SUBJECT: AMENDMENT NO. 66 TO FACILITY OPERATING LICENSE NO. NPF-58-
PERRY NUCLEAR POWER PLANT, UNIT NO. 1 (TAC NO. M83050)

AMENDMENT TO FACILITY OPERATING LICENSE

Amendment No. 66
License No. NPF-58

SAFETY EVALUATION BY THE OFFICE OF NUCLEAR REACTOR REGULATION
RELATED TO AMENDMENT NO. 66 TO FACILITY OPERATING LICENSE NO. NPF-58
THE CLEVELAND ELECTRIC ILLUMINATING COMPANY, ET AL.
PERRY NUCLEAR POWER PLANT, UNIT NO. 1
DOCKET NO. 50-440

Figure 3.6.5.2-1

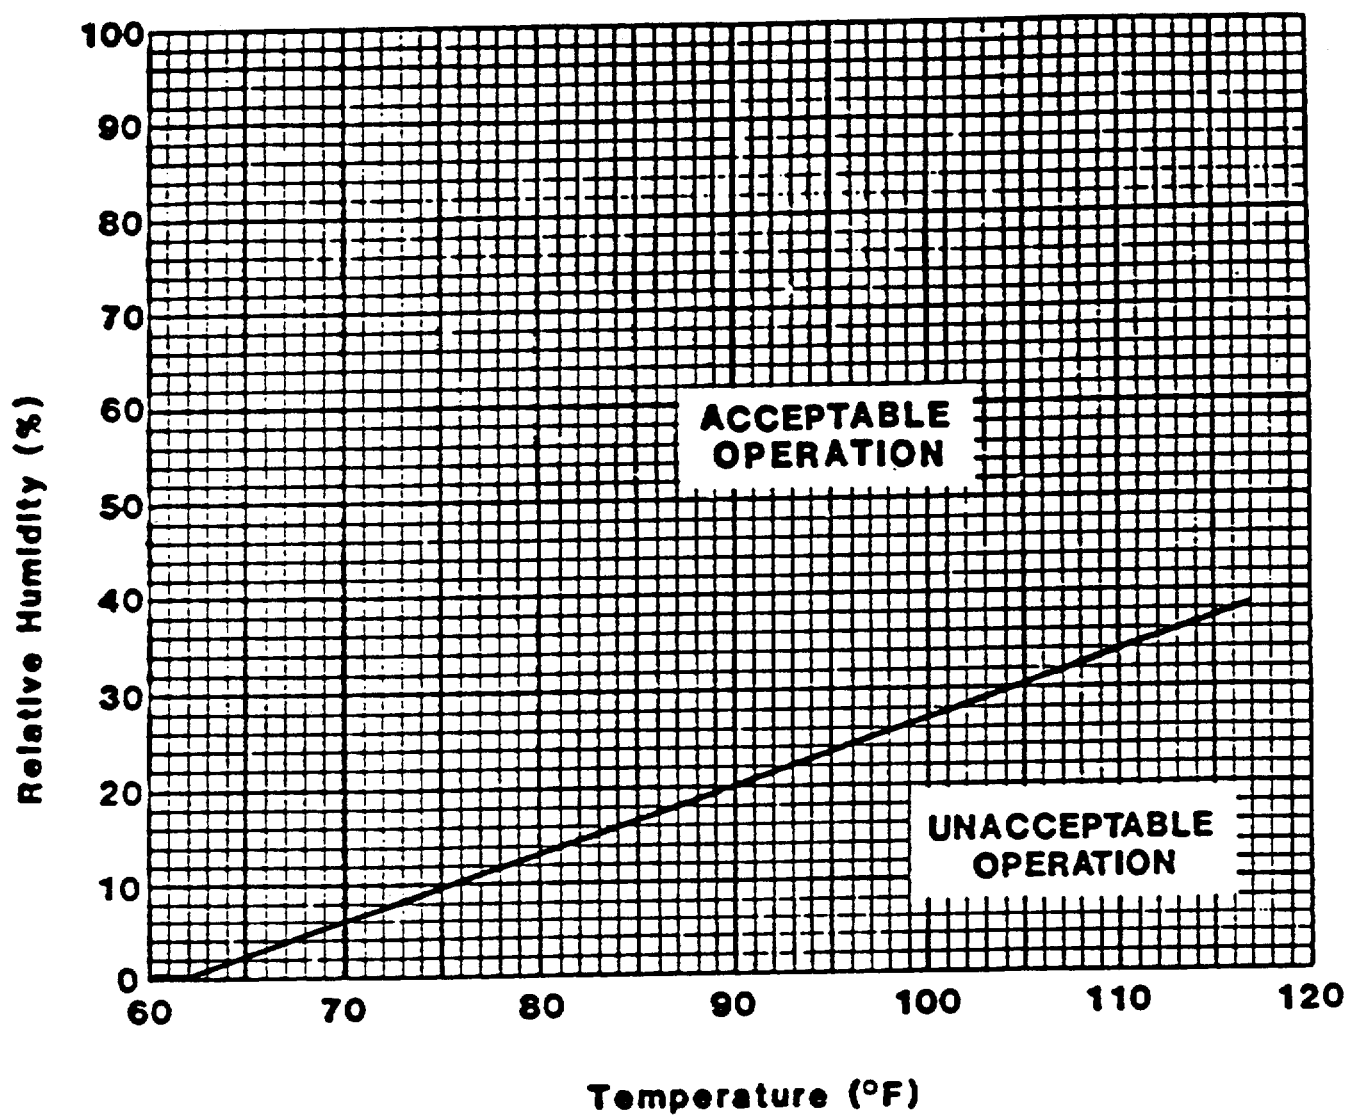
The requested change will extend the line on Figure 3.6.5.2-1, which divides the regions of acceptable versus unacceptable operation for containment relative humidity as it relates to the containment average temperature. Currently, the Figure does not provide any criteria for acceptable versus unacceptable when the average containment air temperature is below 74 °F. Since the containment temperature can go below 74 °F, the extension of the line to 0% relative humidity at or below 62 °F eliminates concern about the need to maintain humidity levels.

The intent of the figure is to show initial relative humidities at various containment temperatures which are acceptable in order to maintain peak vacuum inside containment ≤ 0.72 psi (design is ≤ 0.80 psi) following initiation of both containment spray loops. Additional engineering evaluations indicate that extending the line is conservative.
